STATE OF WASHINGTON  
**STATE BUILDING CODE COUNCIL**

**Title: Withdrawal of 2020 defensible space provisions of the WUI code**

# Appendix: Washington WUI Code Language To Withdraw

**FIGURE 603.2 MEASUREMENTS OF FUEL MODIFICATION DISTANCE**

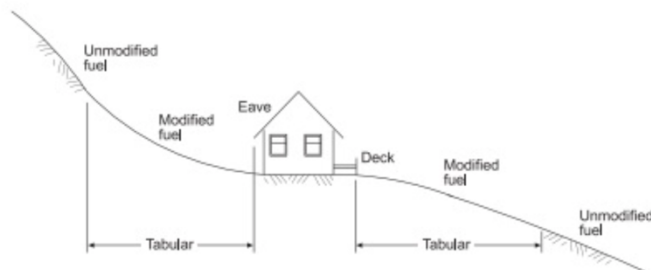
all paragraphs and Table 603.2 and Figure 603.2

Note: Figures, charts, and diagrams in the code cannot be graphically lined out, but if included in this Appendix they are also to be withdrawn (i.e. not adopted).
